RE: Project No. 596-70
Logan County
County Road 10- 5.09
Issue No. 1 Funds

Replace existing Bridge No. 10-5.09, over the Mad River in Jefferson Township,
at a slightly adjusted location, and make all necessary adjustments to the
alignment and profile of County Road No. 10 necessitated by the new bridge, in
accordance with plans prepared by the County and approved by the Director of
Highways.

A review has been made of the detail plans for Logan County Bridge No. 10-5.09 and we have these comments.

DETAIL OF ROCK CHANNEL PROTECTION

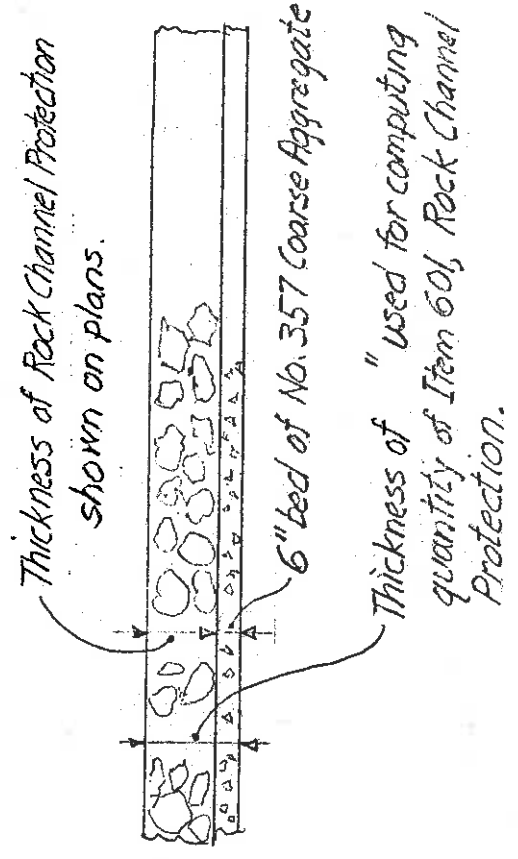
Our Preliminary Design Section recommends, after analysis, that rock channel protection be placed at both abutments and that the crushed aggregate slope protection now shown be eliminated. Attached are Xerox copies of portions of the Site Plan and General Plan marked where changes should be made. Also, attached is a Detail of Rock Channel Protection which shows how the quantity should be figured. The detail should appear in the plans.

Site Plan
LOGAN 10-5109

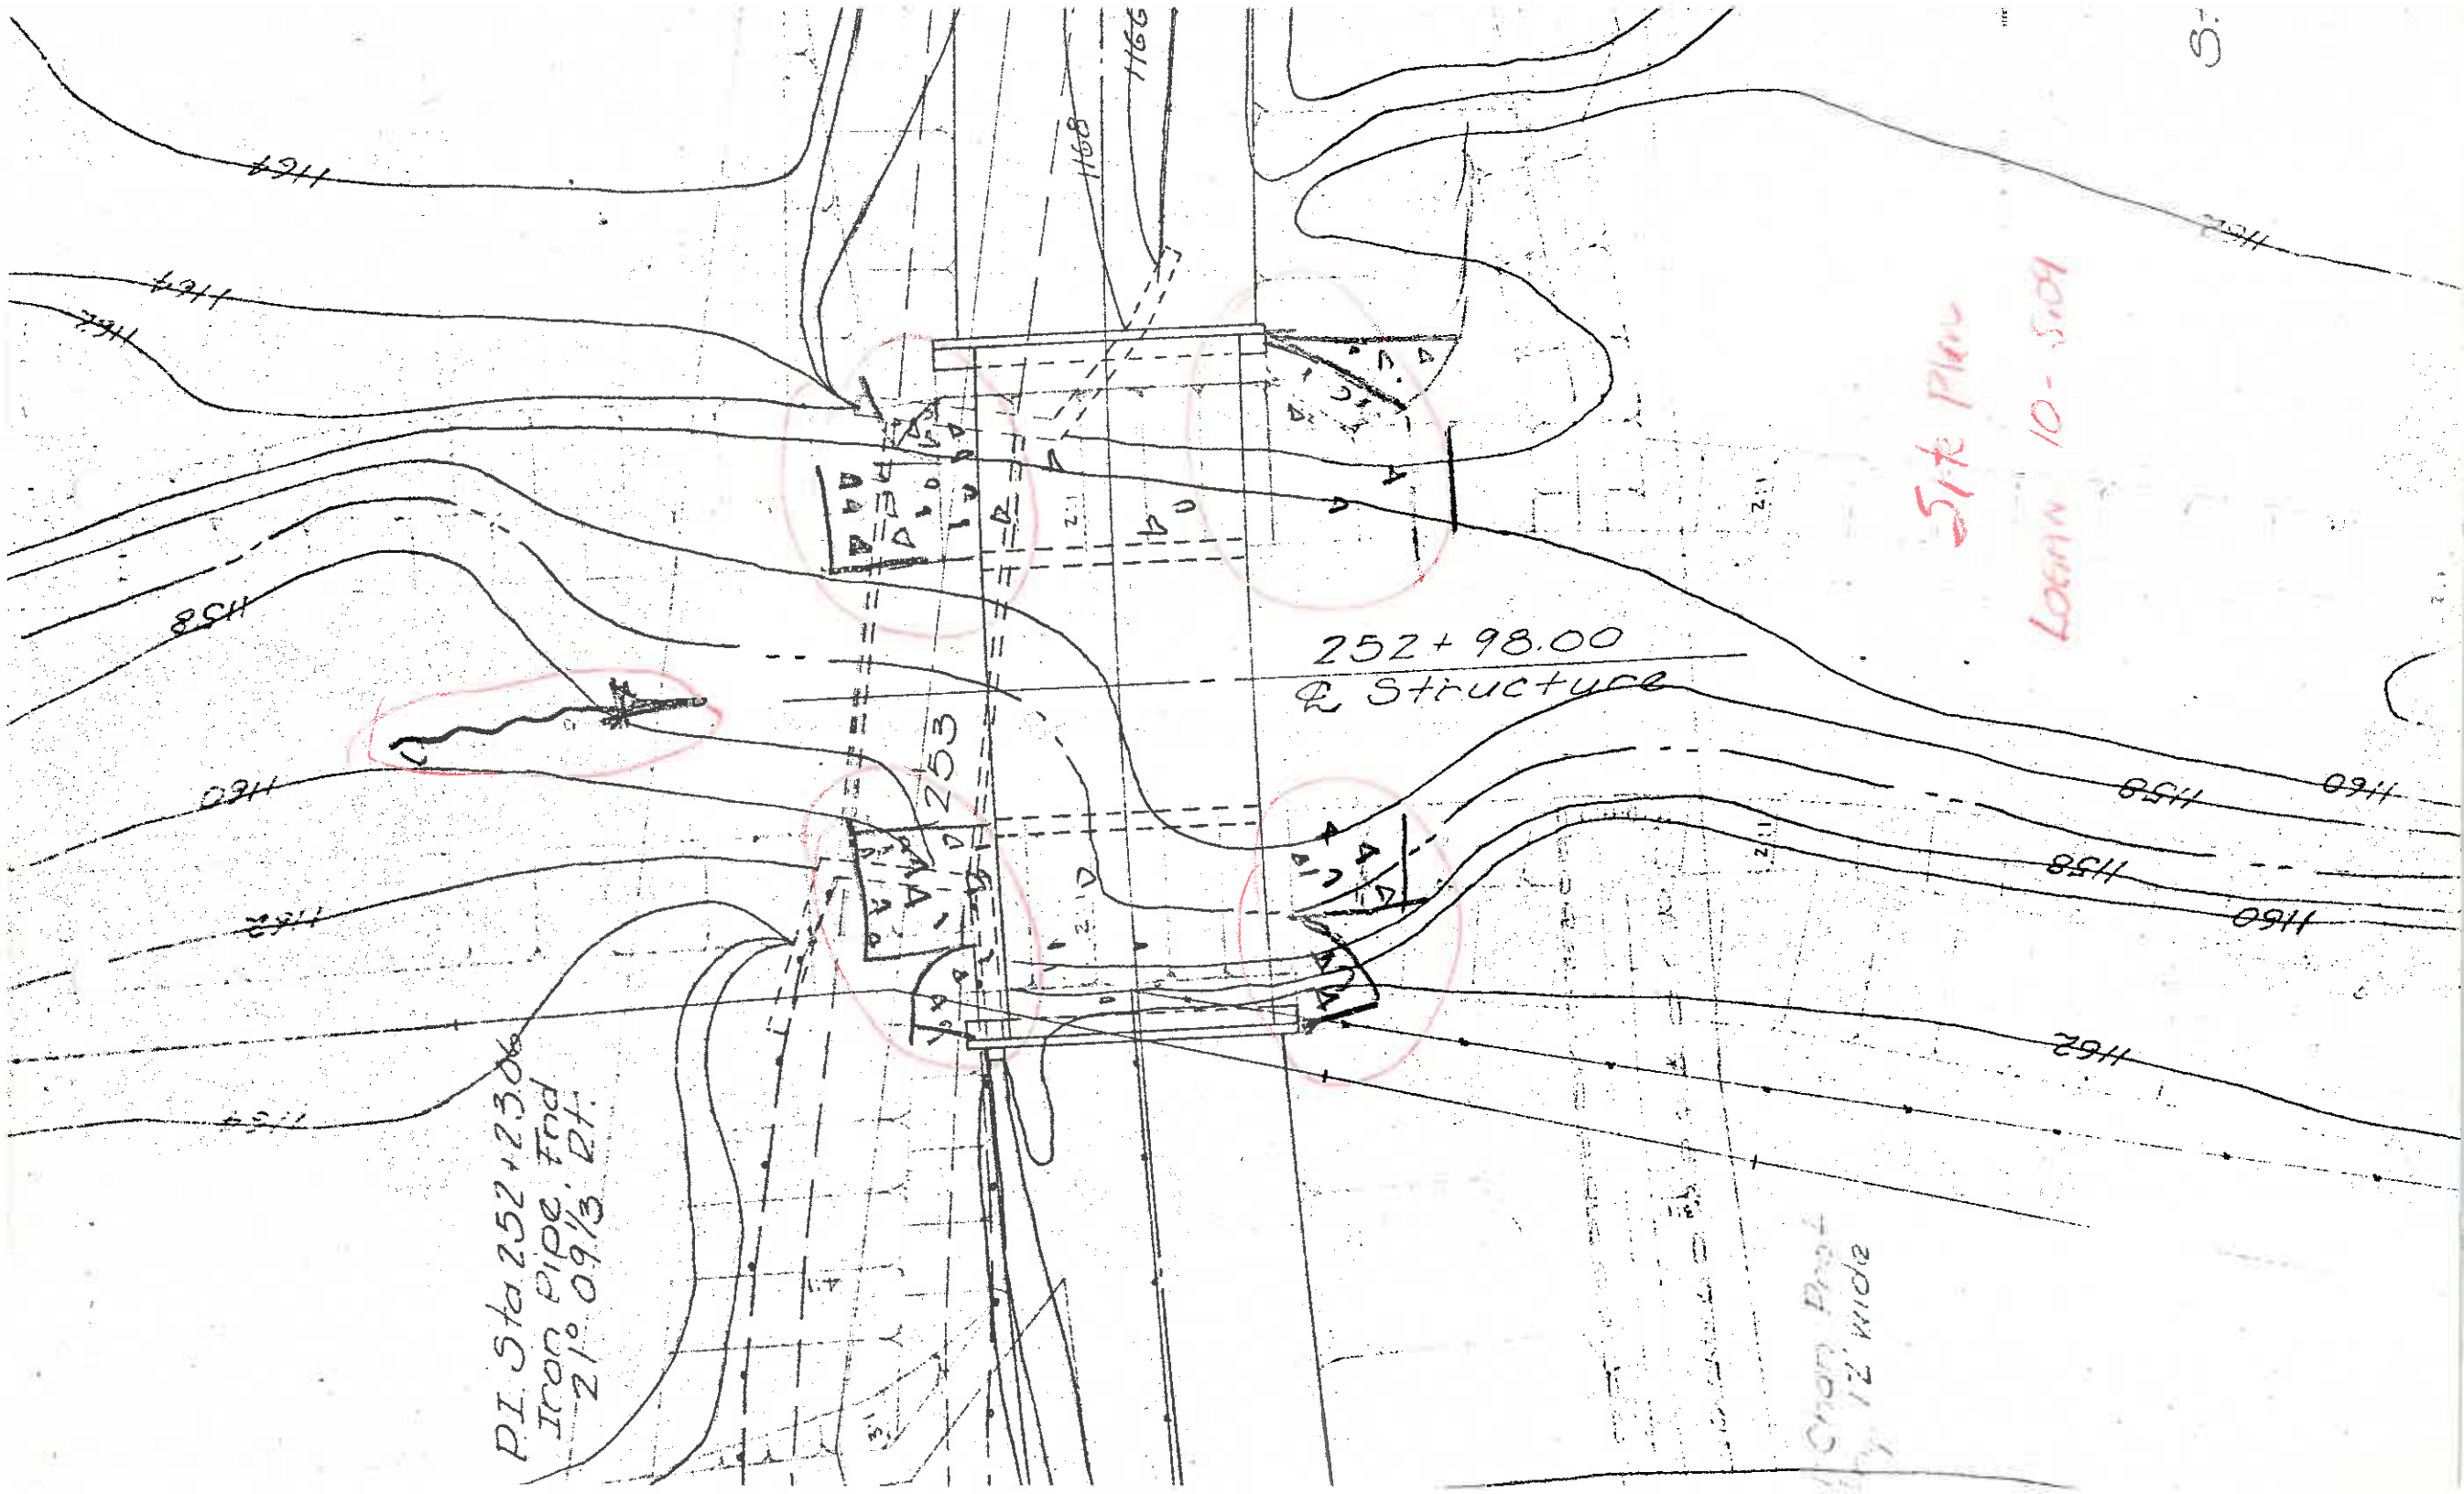
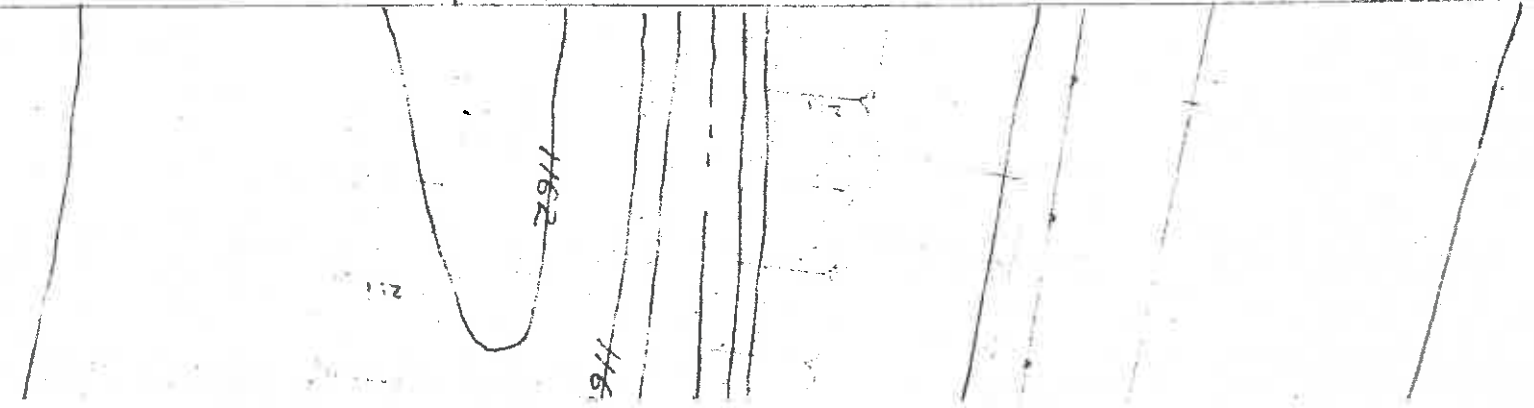
The limits of the Rock Channel Protection should be shown in the plan.

GENERAL PLAN

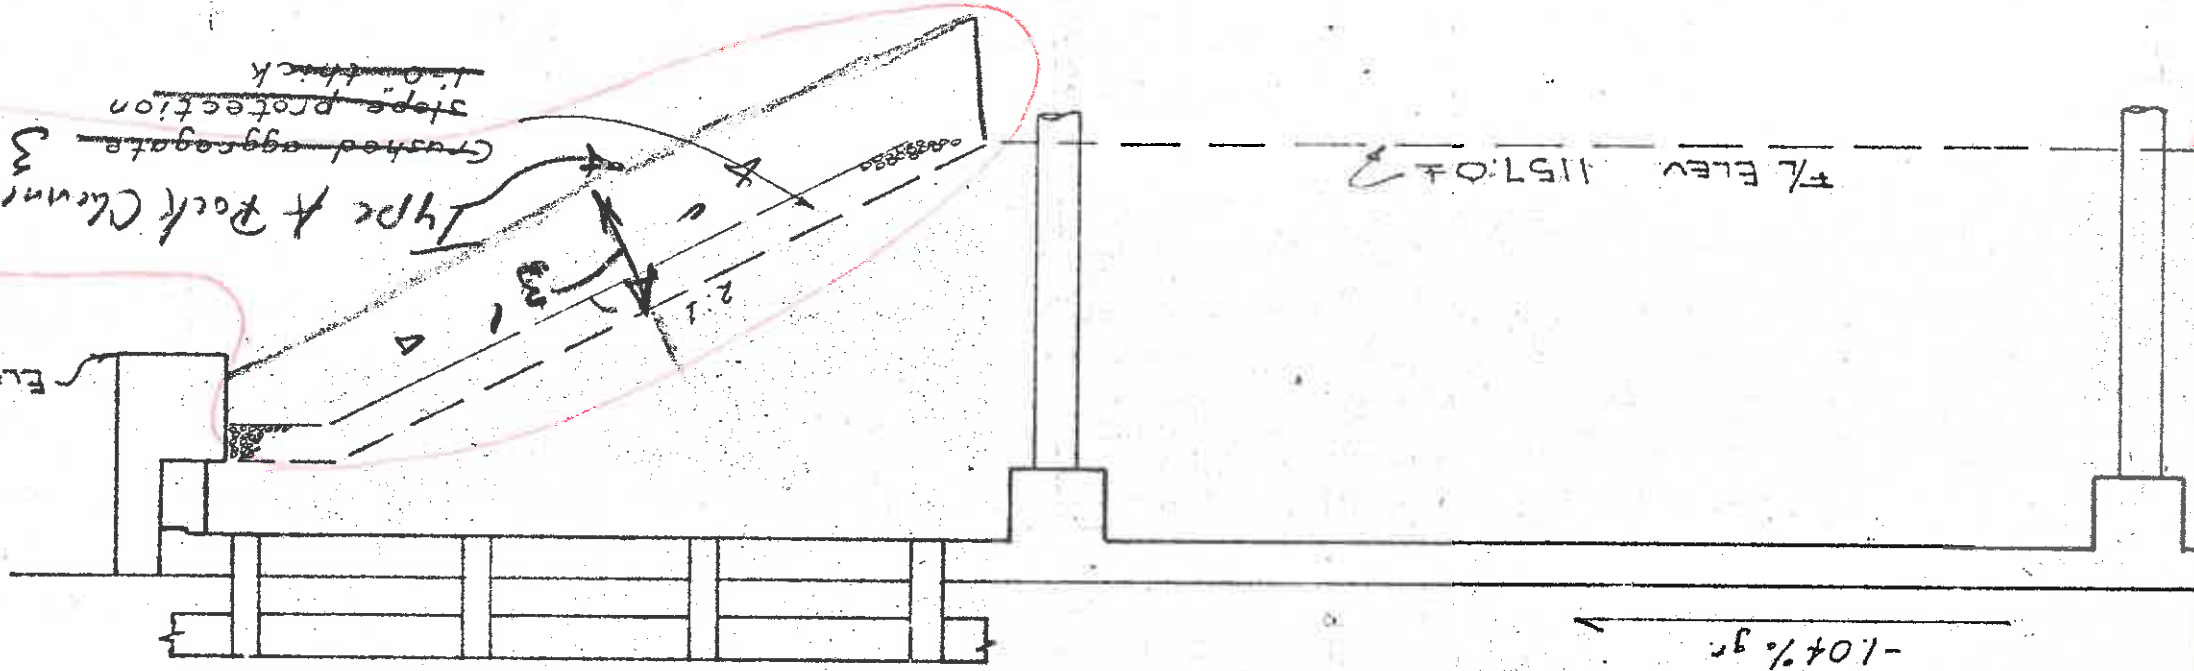
In the Plan View, the out/out width of slab should be shown.

The scale should preferably be omitted on this sheet and sheets 11, 12 and 13 since it will be incorrect on reduced-size prints.

The approach slabs should be shown in Plan and Elevation.
